GREDELL Engineering Resources, Inc.

Re: Pond 001, Cell 1 Professional Engineering Annual Inspection of CCR Impoundment

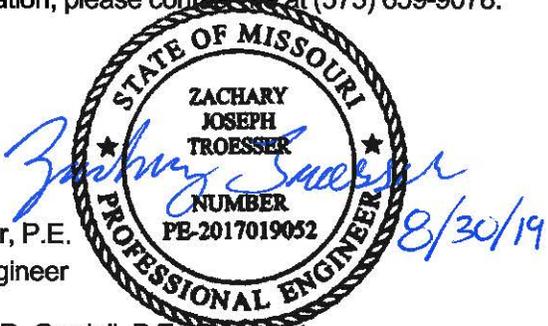
A small gouge was observed in the dense graded aggregate base along the perimeter berm of the dewatering pad. We recommend caution cones or posts similar to common highway delineators be placed at regular intervals along the interior edge of the perimeter berm to assist ash removal operators in recognizing the edge of berm. Posts should not be driven deeper than about 16-inches to ensure the integrity of the clay liner of the dewatering pad. For reference, the de-watering pad was designed to include a 16-inch thick dense graded aggregate base operating surface of an 8-inch layer of drainage aggregate, all over a 2-foot thick clay liner.
